PRODUCT BULLETIN # 16530

TITLE: CMD Packaging change for 7" Reels

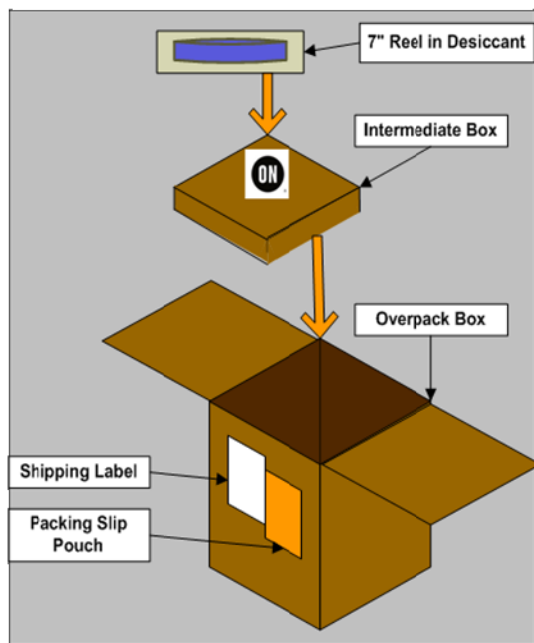
Current: 7" reels placed in desiccant bag in individual Intermediate box.

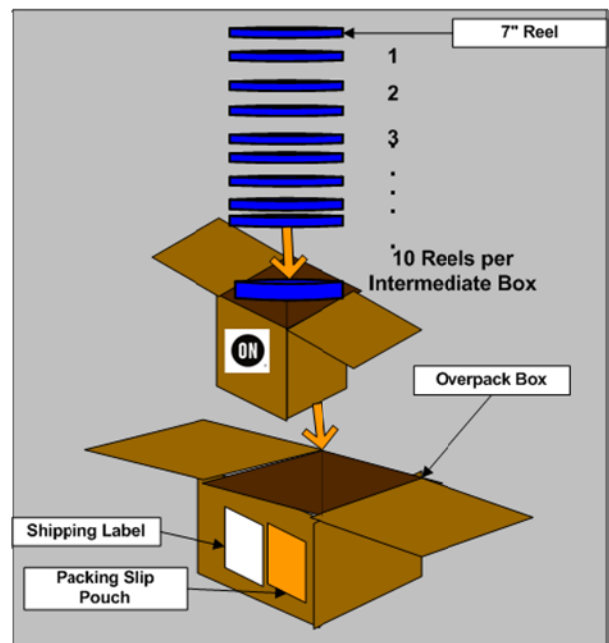
To be: 7" reels placed 10 per Intermediate box, no desiccant bag.
